STATE OF MAINE
DEPARTMENT OF TRANSPORTATION
16 STATE HOUSE STATION
AUGUSTA, MAINE 04333-0016

July 24, 2025
Subject: Fish Passage
WIN: PH20250514WFP
Location: **Woodland**
Amendment No. 10

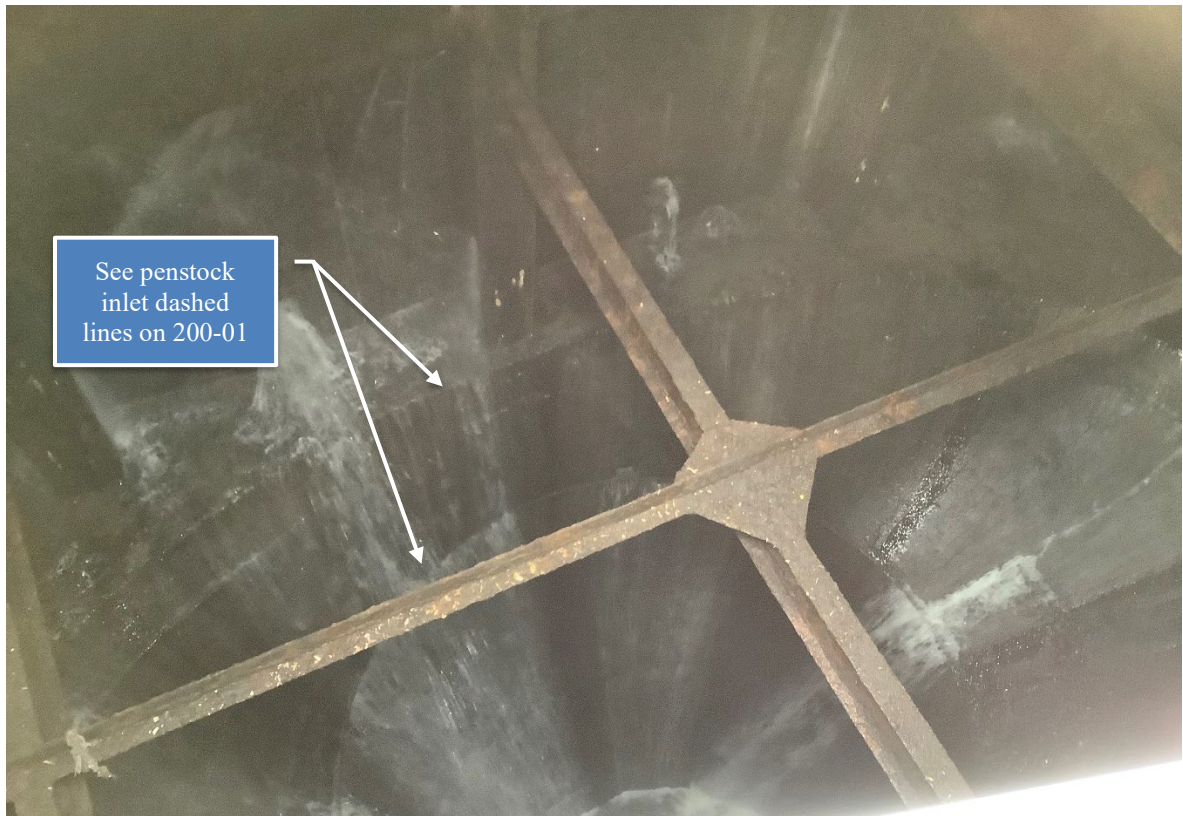
121. **Question:** Drawing 400-02 section B references new concrete between bents 1-12. This call out contradicts other drawings in package. Please clarify which bents require new concrete.

Response: Section B is not applicable at Bents beyond Bent 6 as new concrete ends between Bents 6 and 7; refer to the darker shading of the concrete surface on Sheets 300-01, 300-10, and 400-01 for extents of new concrete. The plan view on Sheet 400-02 was delineated this way because it was the halfway point, allowing retention of the plan on a single sheet at the same/largest drawing scale possible.

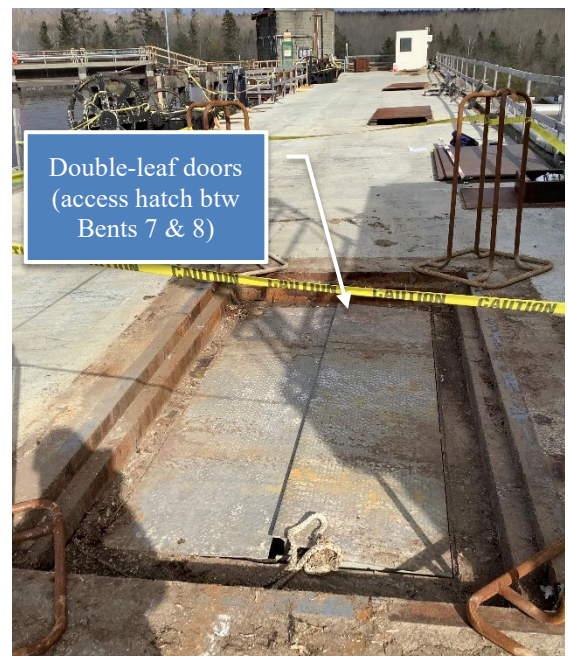
123. **Question:** All fish bypass piping in the trash rack shows the need to core drill 2 holes with a void spanning 18'9". This "void" isn't labeled, please provide details of the area and information on what the access will be to stage the area for access to the work.

Response: The "void" acts as an inner forebay chamber between the intake gates and open penstock inlets. The first photograph below shows a representative penstock inlet, denoted by dashed lines on Sheet 200-01, with the inner forebay chamber in a dewatered state. Dewatering occurs through a drain valve in the penstock, and trash pumps discharging into the penstock opening can be used to maintain workable conditions. The Contractor will be responsible for safety measures if proposing to work within the inner forebay in the dry, such as scaffolding, ladders, stairways, man baskets, and/or temporary railing around the penstock inlet.

Refer to the access hatch and vents noted on C-160 and 200-002 for the Contractor's access into the chamber, which are also shown in the following photographs. The vents are comprised of timber supports topped with steel cover plates. The access hatch has double-leaf hinged doors.

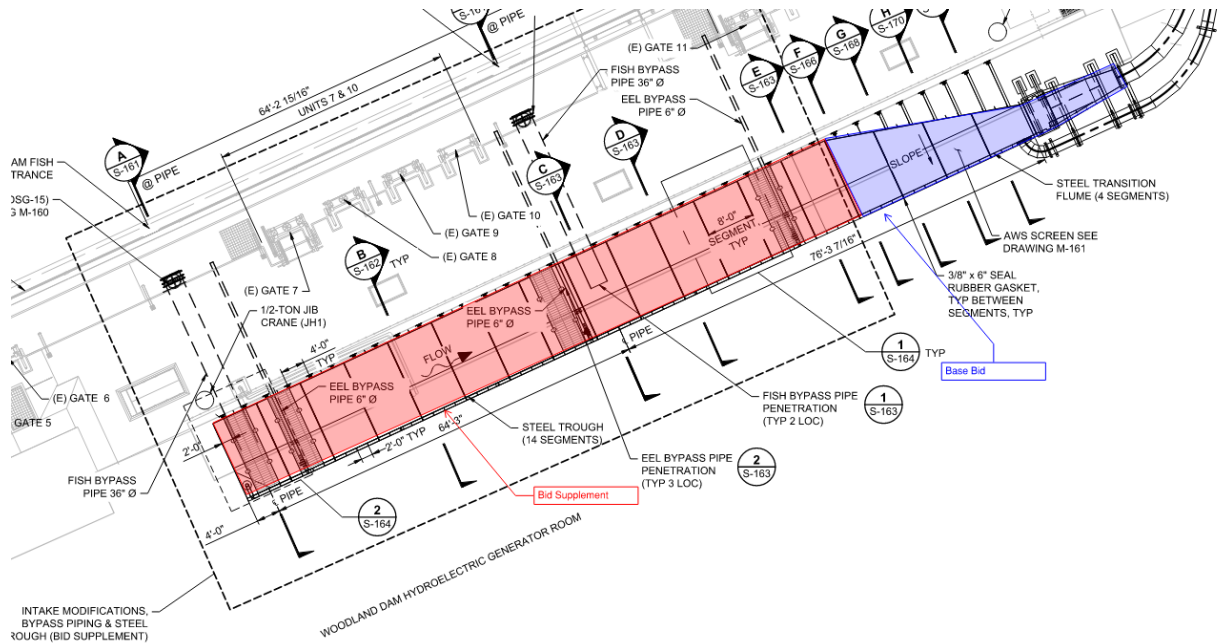
160. **Question:** What is the demarcation for Section 1 to Section 2 for the Bypass Trough. Is it Sheet 166 where the transition starts?

Response: The base bid portion of the bypass flume starts on S-166. Below is the plan view from Sheet S-160 denoting the base bid (Section 1) and the bid supplement (Section 2, dashed area) portions of the bypass flume.
